Refine the Rx Sensitivity/Tx OMA for DR/FR4-500/FR4

Michael He, Penny Xu, Tom Liu, and Rang-Chen(Ryan) Yu

Figure 180-3—OMA_{outer} each lane (max) and OMA_{outer} each lane (min) versus max(TECQ, TDECQ)

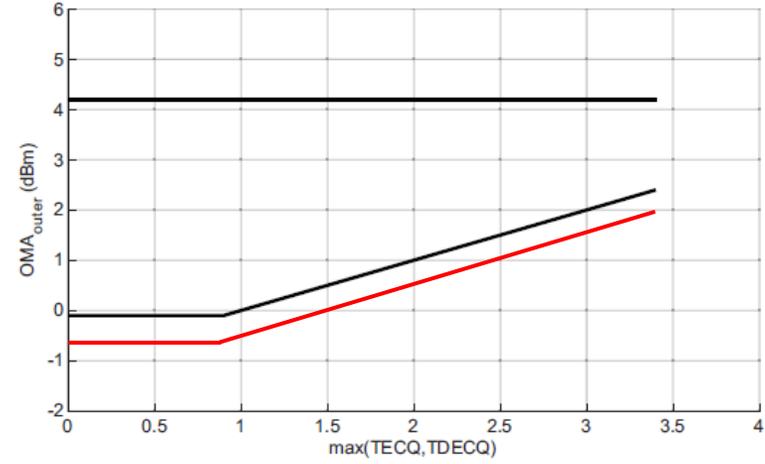
Suggested remedy for DR Tx (reduce 0.6dB)

Description	Reference	200GBASE-DR1	400GBASE-DR2 800GBASE-DR4 1.6TBASE-DR8	Unit
Signaling rate, each lane (range)	—	106.25 ± 50 ppm		GBd
Modulation format	—	PAM4		—
Lane wavelength (range)	180.9.3	1304.5 to 1317.5		nm
Side-mode suppression ratio (SMSR), each lane (min)	180.9.3	30		dB
Average launch power, each lane (max)	180.9.4	4		dBm
Average launch power, each lane ^a (min)	180.9.4	-3.1 ^b -3.7		dBm
Outer optical modulation amplitude (OMA _{outer}), each lane (max)	180.9.5	4.2		dBm
Outer optical modulation amplitude (OMA _{outer}), each lane (min) for max(TECQ, TDECQ) < 0.9 dB for 0.9 dB ≤ max(TECQ, TDECQ) ≤ 3.4 dB	180.9.5	-0.1 -0.7 -1.6 -1+ max(TECQ, TDECQ)		dBm dBm

Figure 180–4—Receiver sensitivity (OMA_{outer}), each lane (max)

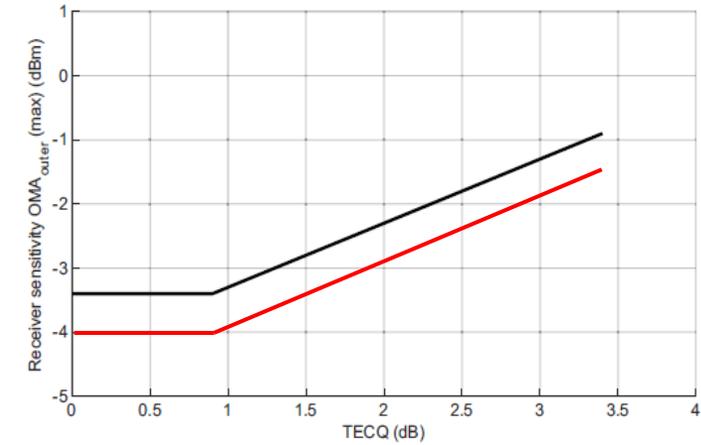
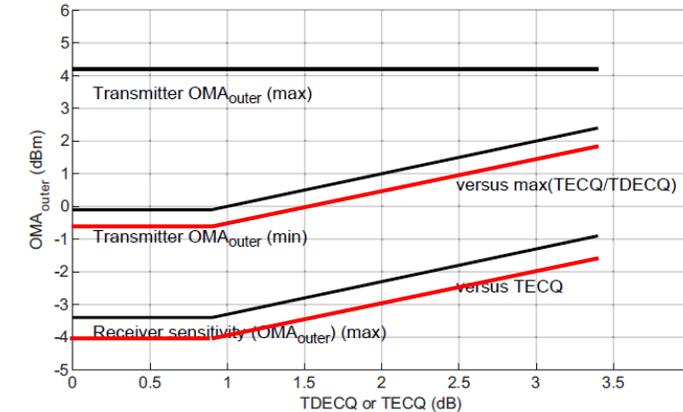
Suggested remedy for DR Rx (reduce 0.6dB)

Description	Reference	Value	Unit
Receiver sensitivity (OMA _{outer}), each lane ^c (max) for TECQ < 0.9 dB for 0.9 dB ≤ TECQ ≤ SECQ	180.9.15	-3.4 -4.0 -4.9 -4.3 + TECQ	dBm
Stressed receiver sensitivity (OMA _{outer}), each lane ^c (max)	180.9.16	-0.9 -1.5	dBm
Conditions of stressed receiver sensitivity test ^d :			
Stressed eye closure for PAM4 (SECQ), lane under test	—	3.4	dB
OMA _{outer} of each aggressor lane ^e	—	4.2	dBm

Figure 181-3—OMA_{outer} each lane (max) and OMA_{outer} each lane (min) versus max(TECQ, TDECQ)

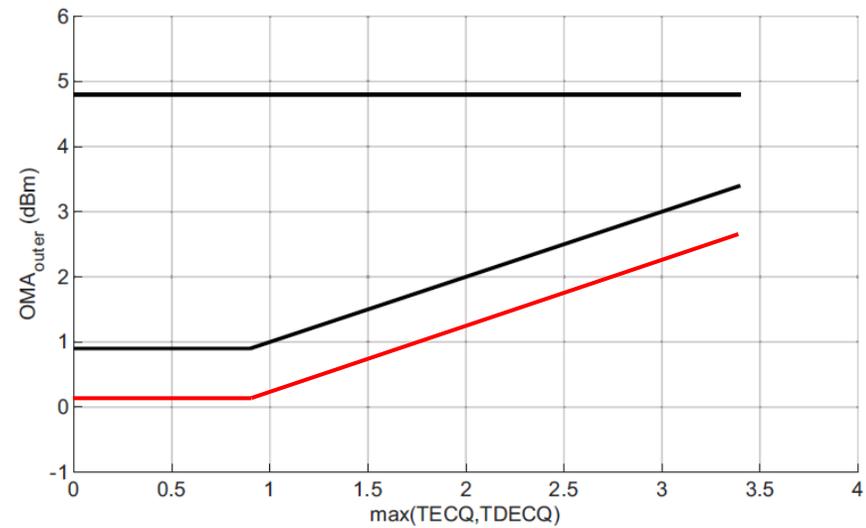
Suggested remedy for FR4-500 Tx (reduce 0.8dB)

Description	Reference	800GBASE-FR4-500	Unit
Signaling rate, each lane (range)	—	106.25 ± 50 ppm	GBd
Modulation format	—	PAM4	—
Lane wavelengths (range)	181.9.3	1264.5 to 1277.5 1284.5 to 1297.5 1304.5 to 1317.5 1324.5 to 1337.5	nm
Side-mode suppression ratio (SMSR), each lane (min)	181.9.3	30	dB
Total average launch power (max)	181.9.4	10.9	dBm
Average launch power, each lane (max)		4.9	dBm
Average launch power, each lane ^a (min)		-2.1 ^b -2.9	dBm
Outer optical modulation amplitude (OMA _{outer}), each lane (max)	181.9.5	4.8	dBm
Outer optical modulation amplitude (OMA _{outer}), each lane (min) for max(TECQ, TDECQ) < 0.9 dB for 0.9 dB ≤ max(TECQ, TDECQ) ≤ 3.4 dB		0.9 0.1 -0.8 + max(TECQ, TDECQ)	dBm dBm

Figure 181-4—Receiver sensitivity (OMA_{outer}), each lane (max)

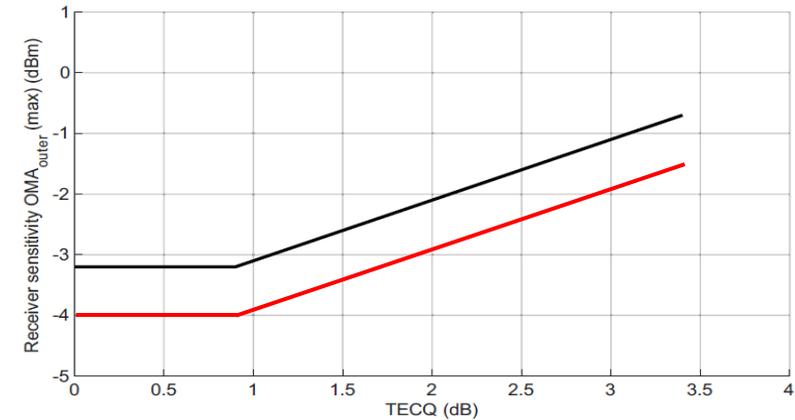
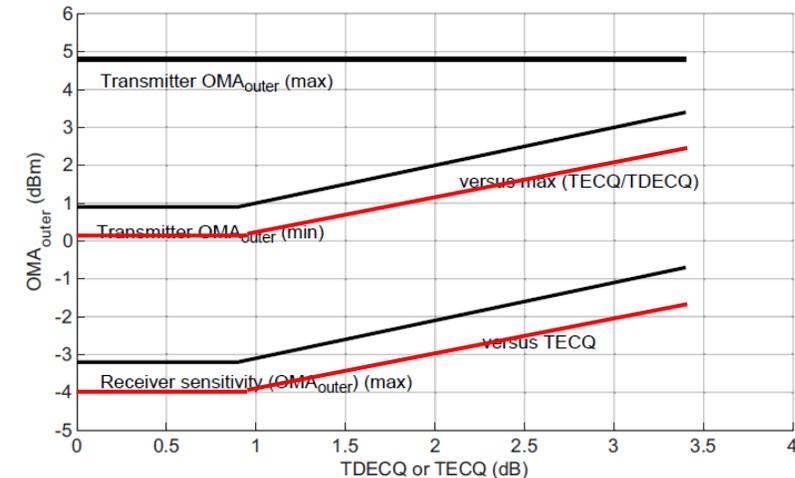
Suggested remedy for FR4-500 Rx (reduce 0.8dB)

Description	Reference	800GBASE-FR4-500	Unit
Signaling rate, each lane (range)	—	106.25 ± 50 ppm	GBd
Modulation format	—	PAM4	—
Lane wavelengths (range)	181.9.3	1264.5 to 1277.5 1284.5 to 1297.5 1304.5 to 1317.5 1324.5 to 1337.5	nm
Damage threshold ^a , each lane	—	5.9	dBm
Average receive power, each lane (max)	—	4.9	dBm
Average receive power, each lane ^b (min)	—	-5.6 -6.4	dBm
Receive power (OMA _{outer}), each lane (max)	—	4.8	dBm
Difference in receive power between any two lanes (OMA _{outer}) (max)	—	4.1	dB
Receiver reflectance (max)	—	-26	dB
Receiver sensitivity (OMA _{outer}), each lane ^c (max) for TECQ < 0.9 dB for 0.9 dB ≤ TECQ ≤ SECQ	181.9.15	-3.2 -4.0 -4.9 -4.1 + TECQ	dBm dBm
Stressed receiver sensitivity (OMA _{outer}), each lane ^c (max)	181.9.16	-0.7 -1.5	dBm
Conditions of stressed receiver sensitivity test: ^d			
Stressed eye closure for PAM4 (SECQ), lane under test	—	3.4	dB
OMA _{outer} of each aggressor lane	—	1.3	dBm

Figure 183–3—OMA_{outer} each lane (max) and OMA_{outer} each lane (min) versus max(TECQ, TDECQ) for 800GBASE-FR4 and 800GBASE-LR4

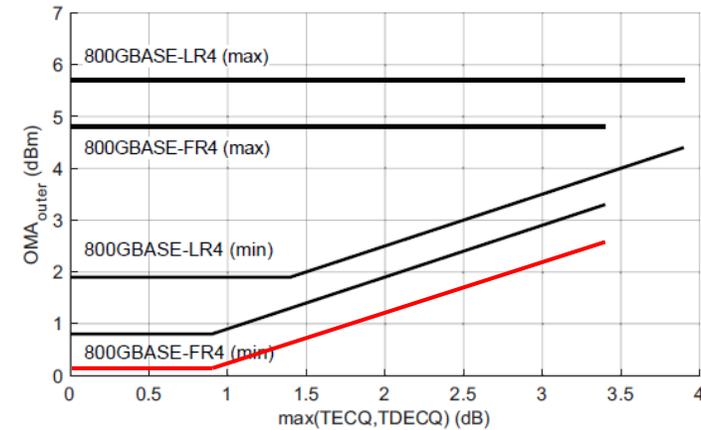
Suggested remedy for FR4 Tx (reduce 0.7dB)

$$0.5 + \max(\text{TECQ}, \text{TDECQ})$$

~~$$-0.1 + \max(\text{TECQ}, \text{TDECQ}) \quad (183-1)$$~~

~~$$0.5 + \max(\text{TECQ}, \text{TDECQ}) \quad (183-2)$$~~

Figure 183-4—Receiver sensitivity (OMA_{outer}), each lane (max) for 800GBASE-FR4 and 800GBASE-LR4

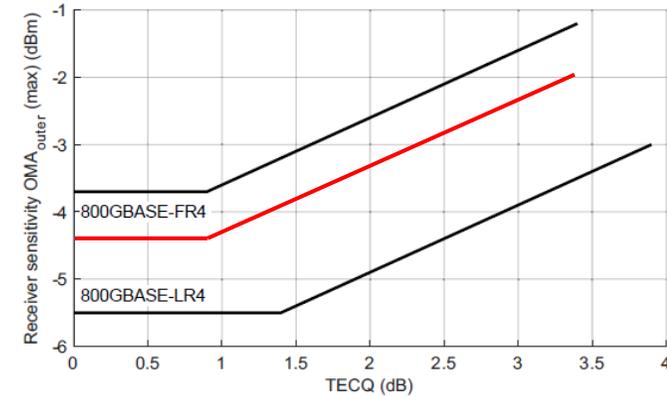
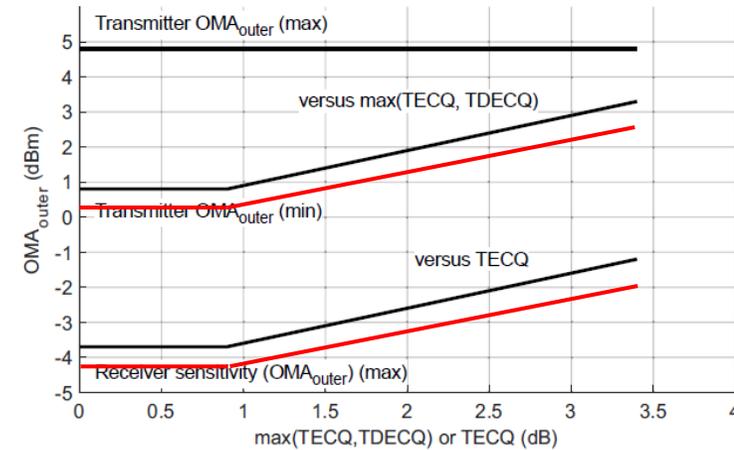
Suggested remedy for FR4 Rx (reduce 0.7dB)

Description	Defined in	800GBASE-FR4	800GBASE-LR4	Unit
Signaling rate, each lane (range)	—	113.4375 ± 50 ppm		GBd
Modulation format	—	PAM4		—
Lane wavelengths (range)	183.9.3	1264.5 to 1277.5 1284.5 to 1297.5 1304.5 to 1317.5 1324.5 to 1337.5	1294.53 to 1296.59 1299.02 to 1301.09 1303.54 to 1305.63 1308.09 to 1310.19	nm
Damage threshold ^a , each lane	—	5.9	6.5	dBm
Average receive power, each lane (max)	—	4.9	5.5	dBm
Average receive power, each lane ^b (min)	—	-6.2 -6.9	-7.4	dBm
Receive power (OMA _{outer}), each lane (max)	—	4.8	5.7	dBm
Difference in receive power between any two lanes (OMA _{outer}) (max)	—	4.1	3.3	dB
Receiver reflectance (max)	—	-26		dB
Receiver sensitivity (OMA _{outer}), each lane ^c (max) for TECQ < 0.9 dB for 0.9 dB ≤ TECQ ≤ SECQ for TECQ < 1.4 dB for 1.4 dB ≤ TECQ ≤ SECQ	183.9.15	-3.7 -4.4 -5.3 -4.6 + TECQ — —	— — -5.5 -6.9 + TECQ	dBm dBm dBm dBm
Stressed receiver sensitivity (OMA _{outer}), each lane ^c (max)	183.9.16	-1.2 -1.9	-3	dBm
